Addendum

Reconstruction at
Mahopac High School
Mahopac Middle School
Mahopac Falls School
Bus Garage
New Pump House

BID Addendum No. 3
to
Drawings and Project Manual

February 22, 2021

Electrical Site Demolition Plan

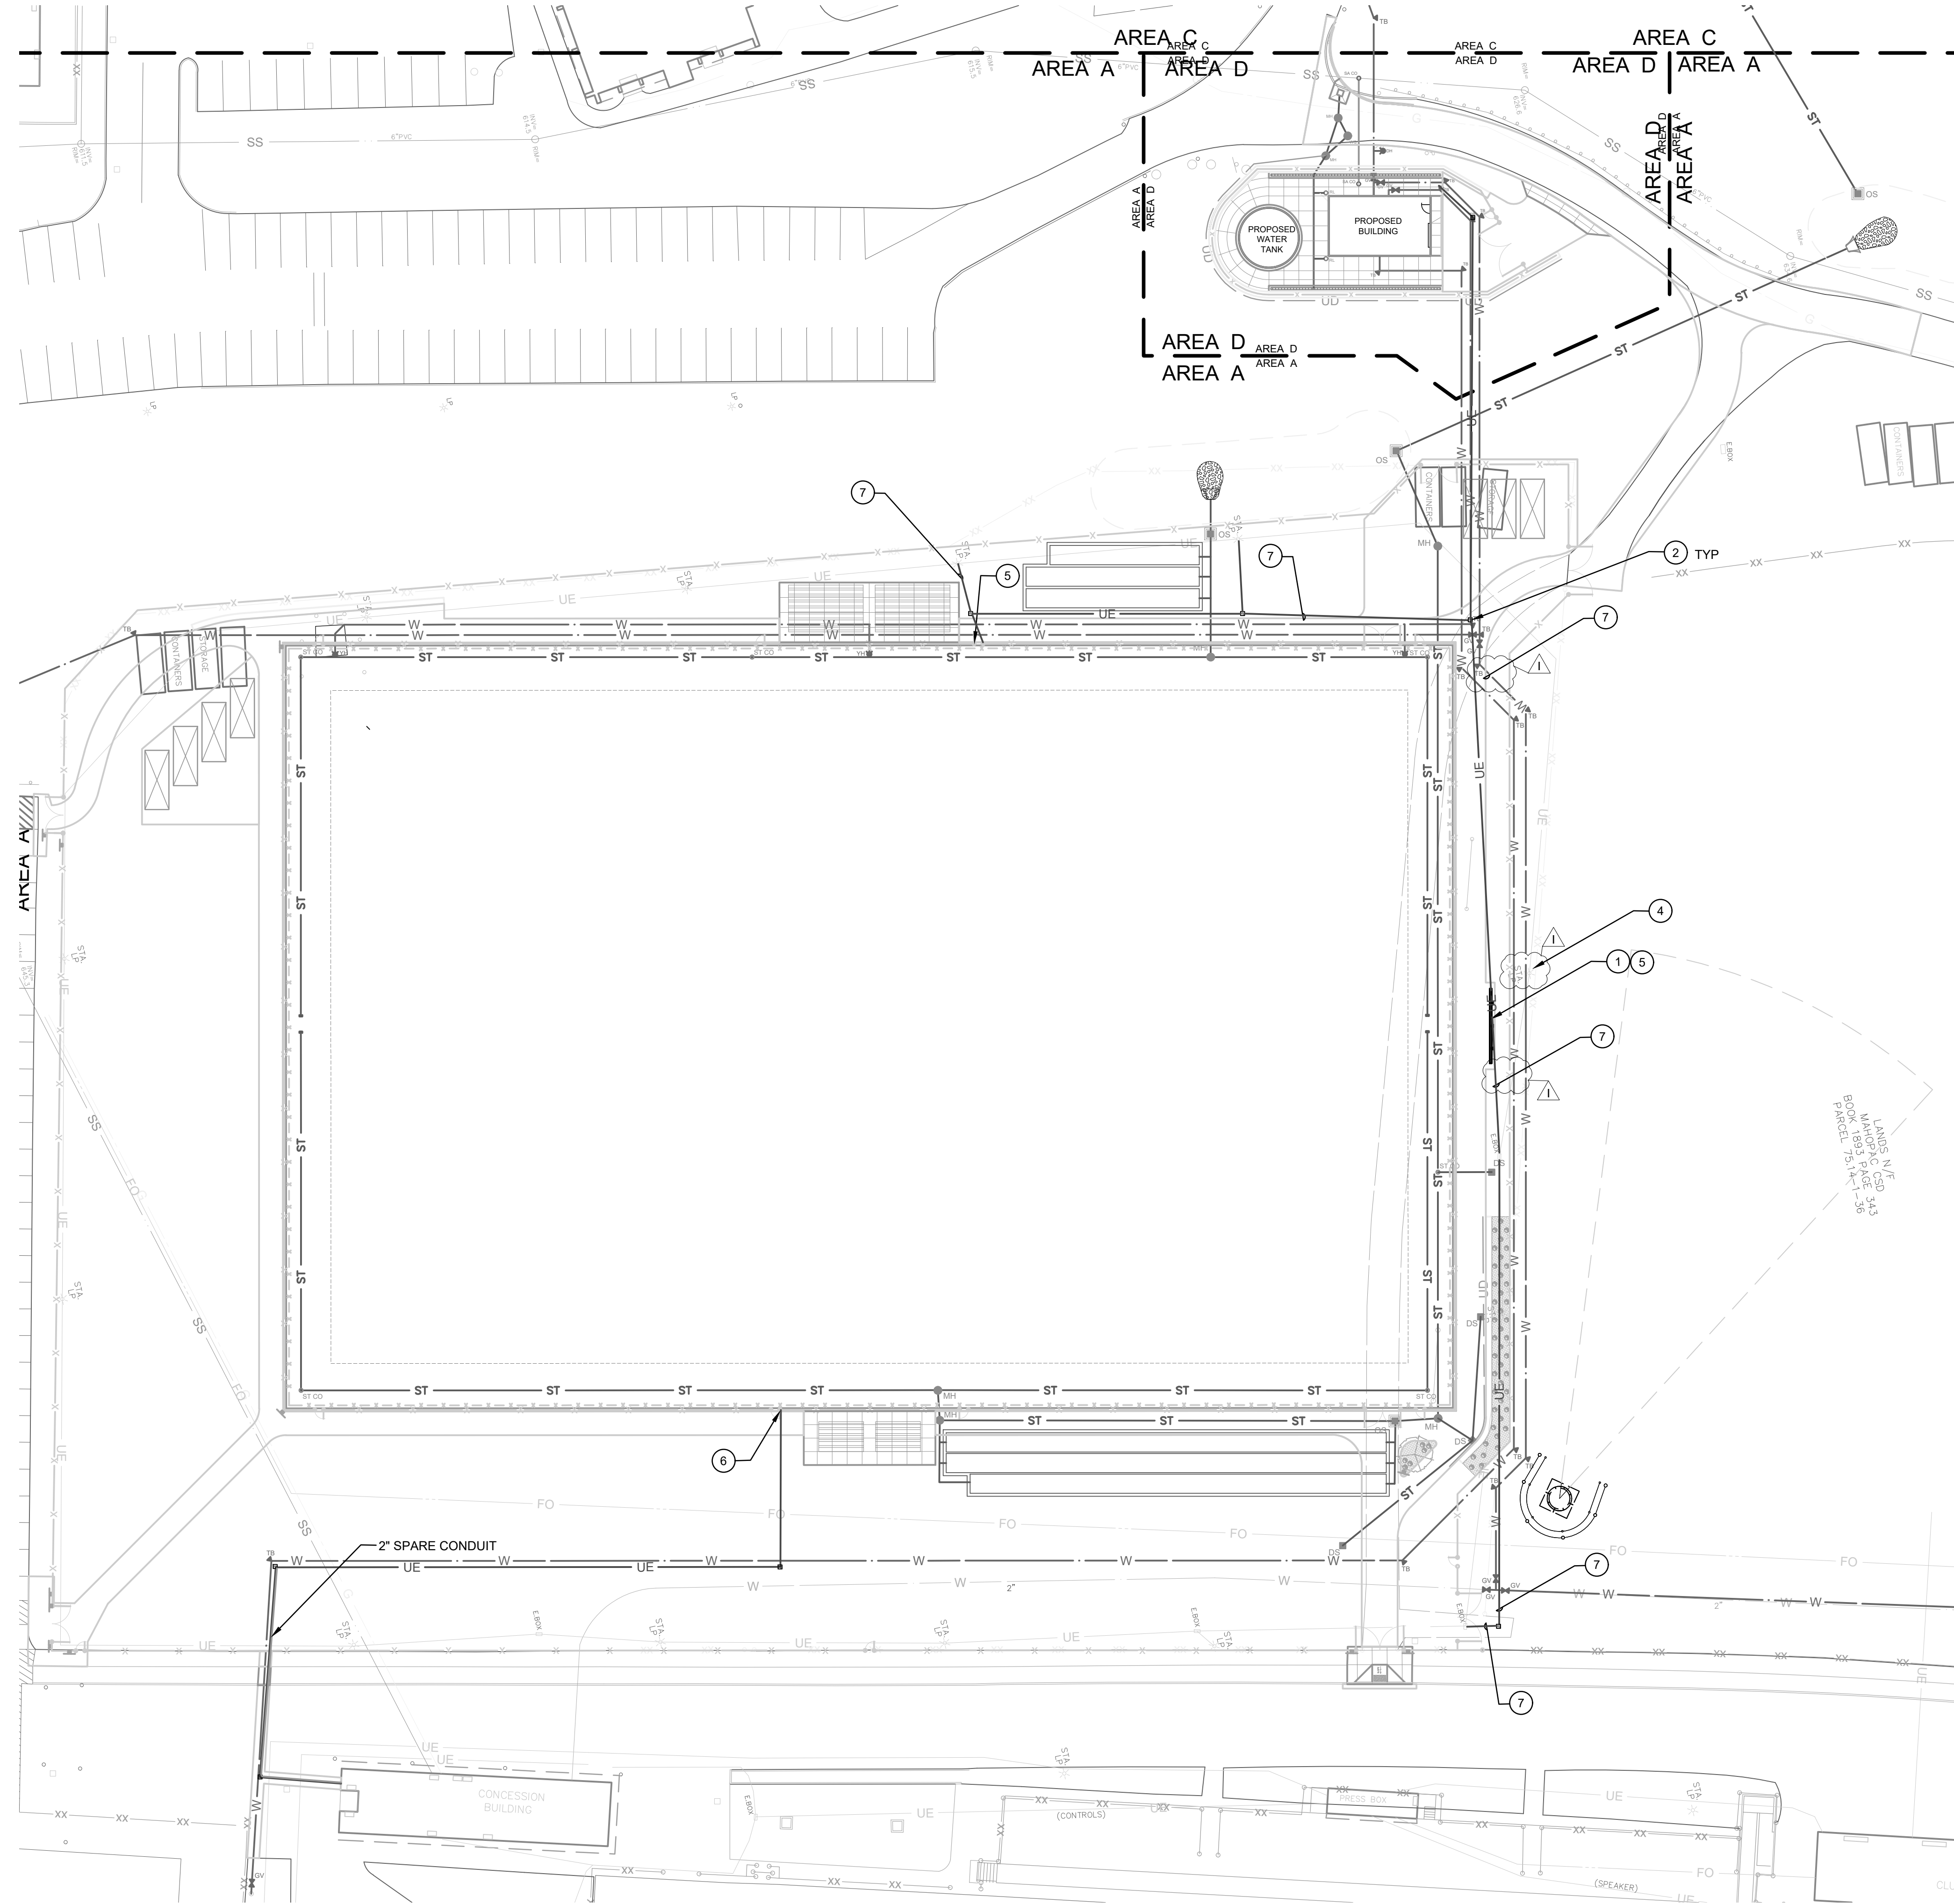
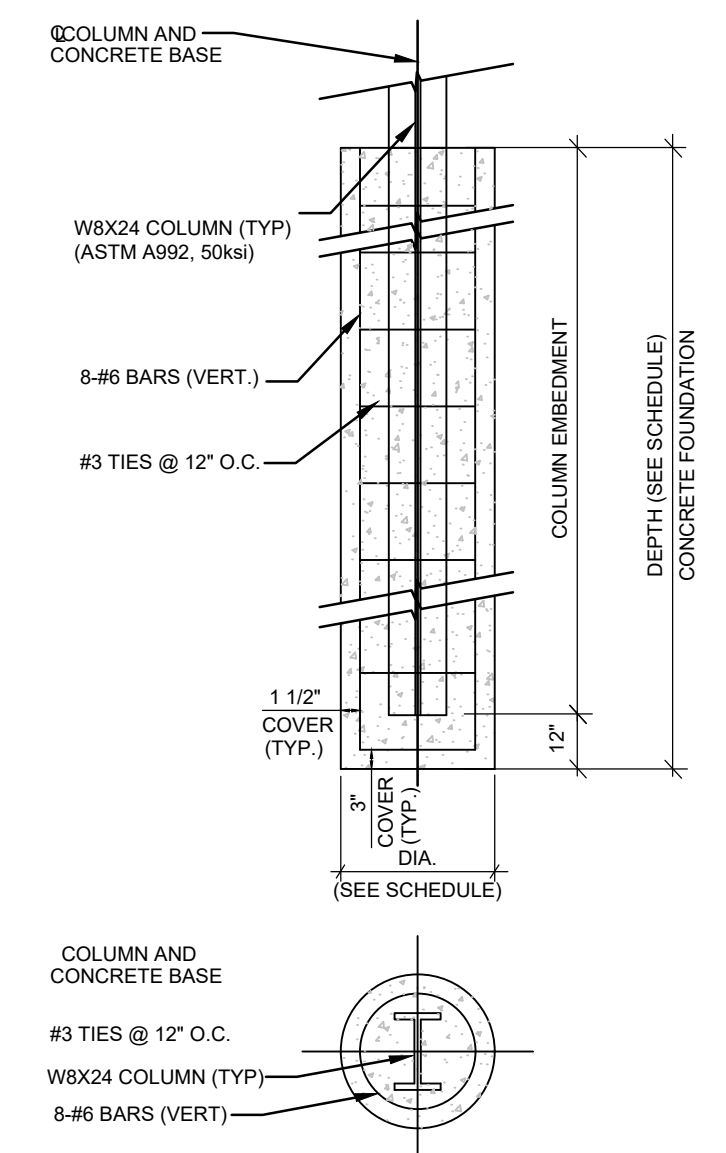
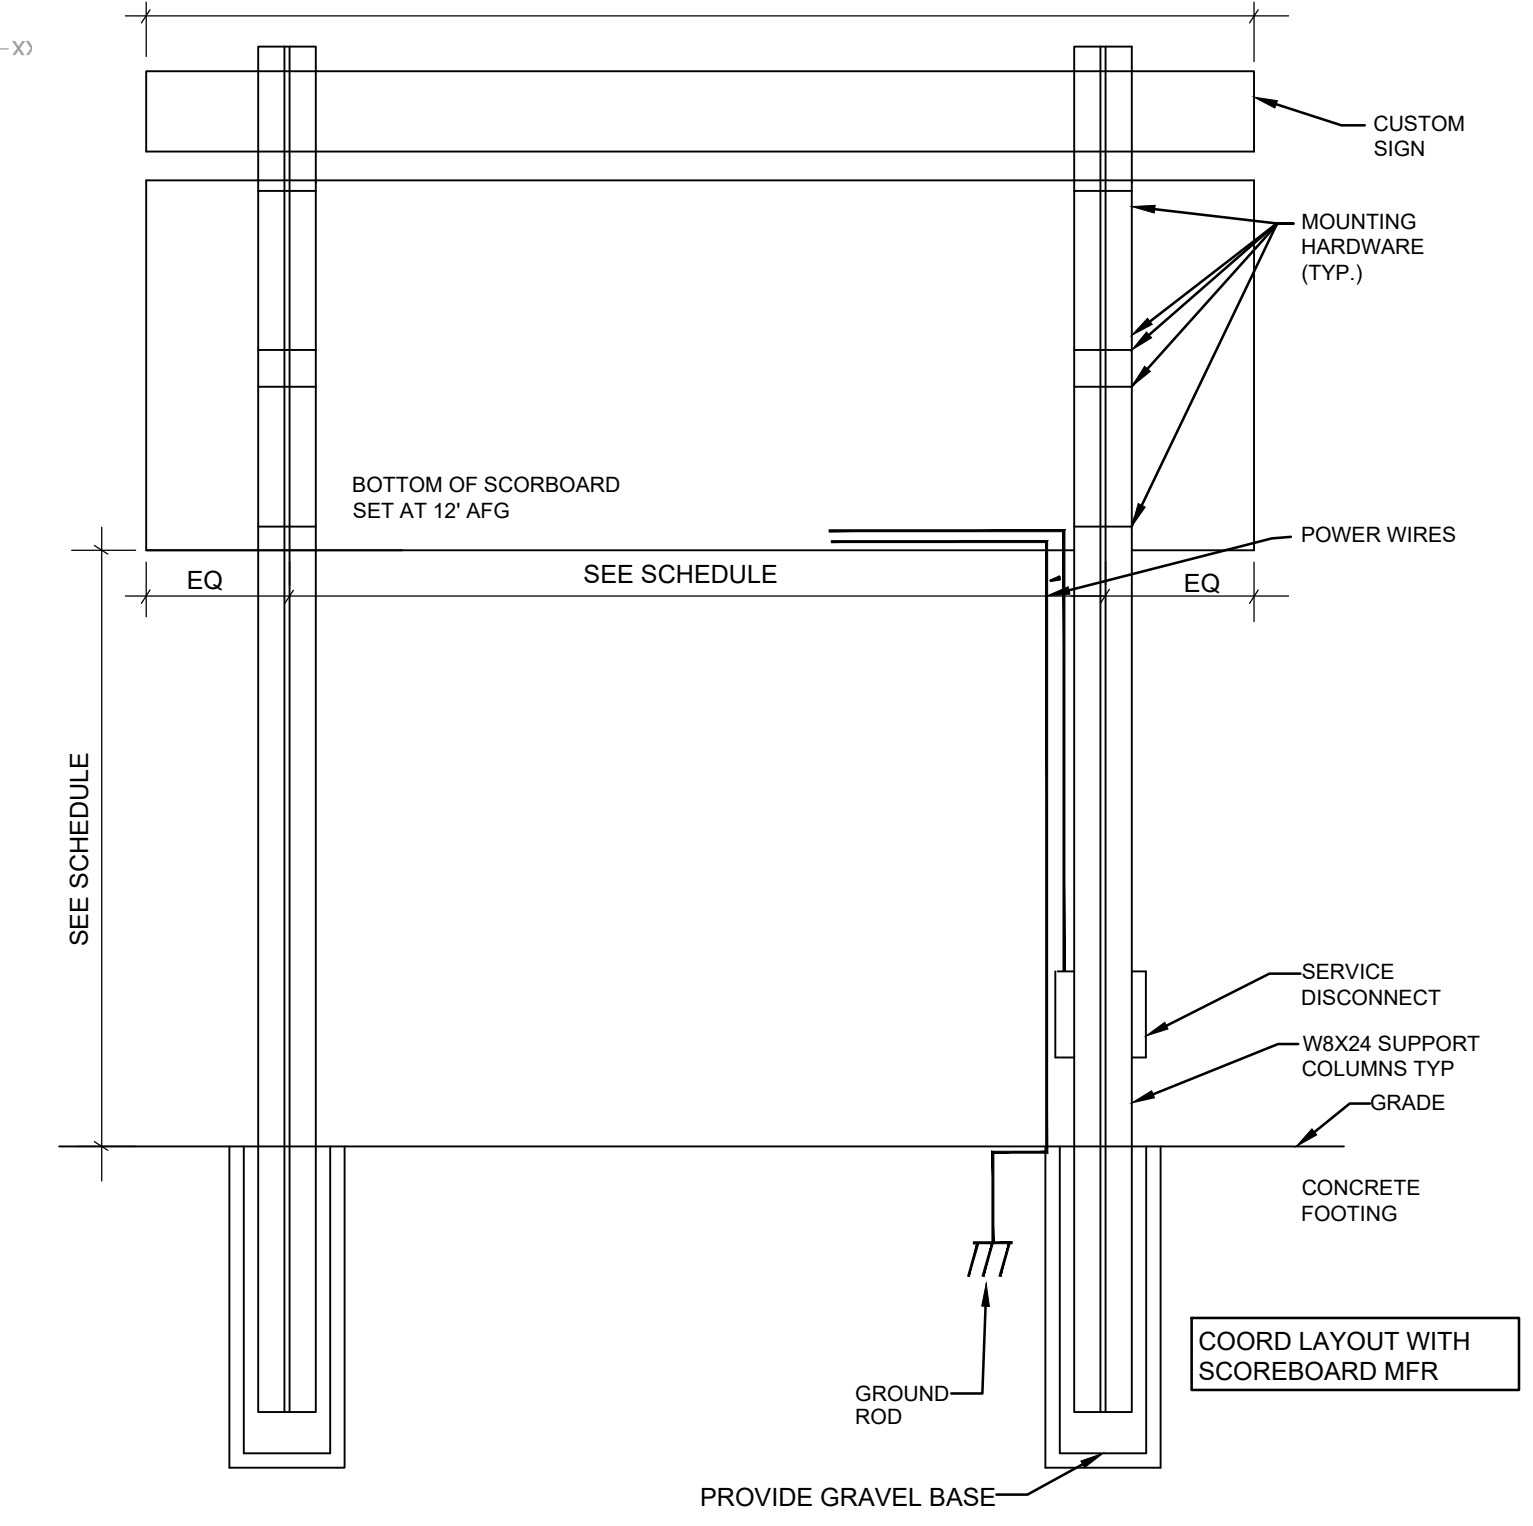
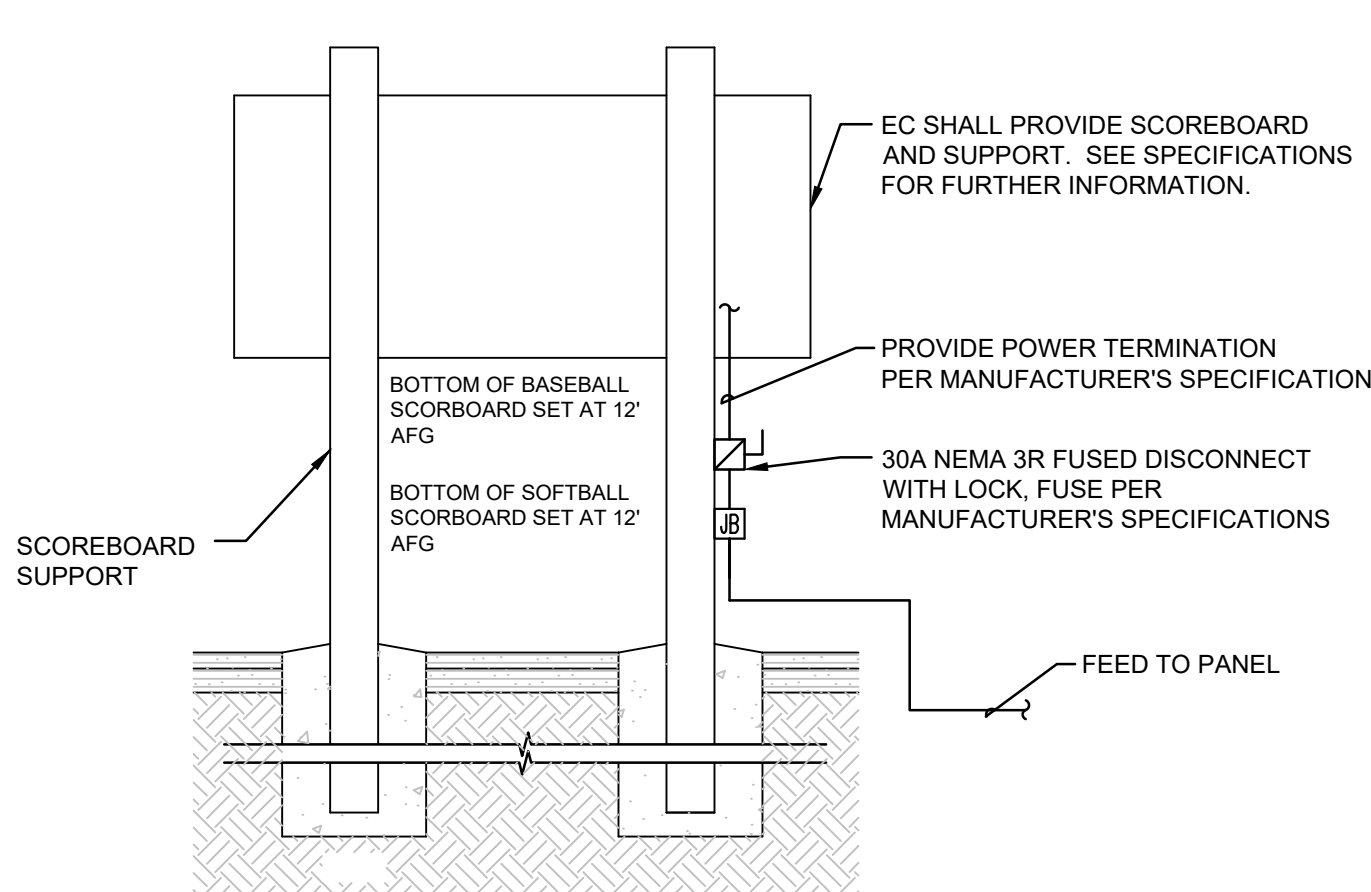
Question: (Please be specific) 1. note 1 to reroute existing feeder, where are we rerouting this to, please clarify scope of work?

Electrical Site Plan - Site Lighting and Scoreboard

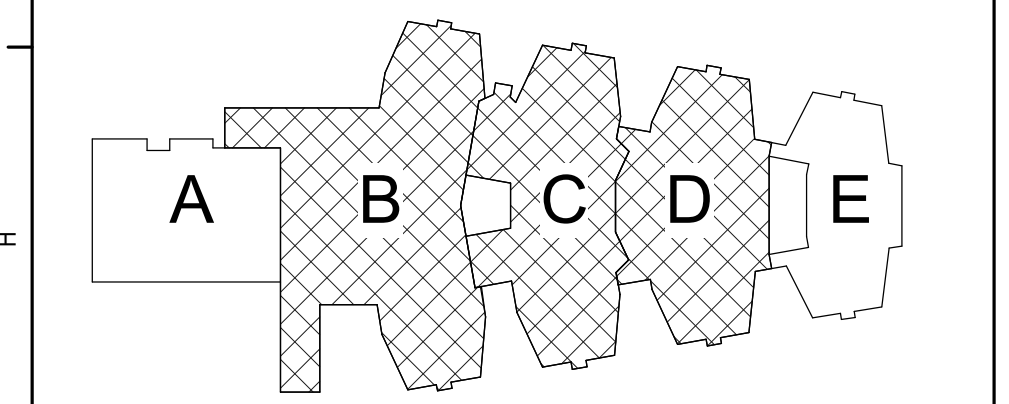
Question: (Please be specific) 1. can you confirm that the GC is responsible for the footings/support of the scoreboard we will furnish and install? Please clarify which trade is doing what scope for the scoreboard?

Question: (Please be specific) 1. HE100 shows panel schedule with circuit feeding scoreboard, and receptacle at scoreboard. Plan AE002 note 3 states for us to extend existing conduit to pumphouse (what size conduit)? Please clarify this scope. I assume no work needs to be done to exiting conduit shown on A001 and that the scoreboard and outlet per notes 1 &5 on AE002 will be powered by a new conduit and feeder coming from the pumphouse, please clarify/confirm scope?

Question: (Please be specific) 1. detail 4/AE002 shows a nema 3R 30A fused disconnect to feed scoreboard, but circuit on panel schedule PH1 in pumphouse shows this as a 20A single pole circuit, please confirm size of disconnect and feeder size for this circuit?
2. note 4 on AE002 does not appear on the plans, is there any scope here we need to include?

The Electrical contractor is to provide a turnkey installation for the scoreboard as shown on AE002. This includes foundations and structure.

- 1. SIZE SHOWN IS CORRECT
- 2. REFER TO ADDENDUM NO 3
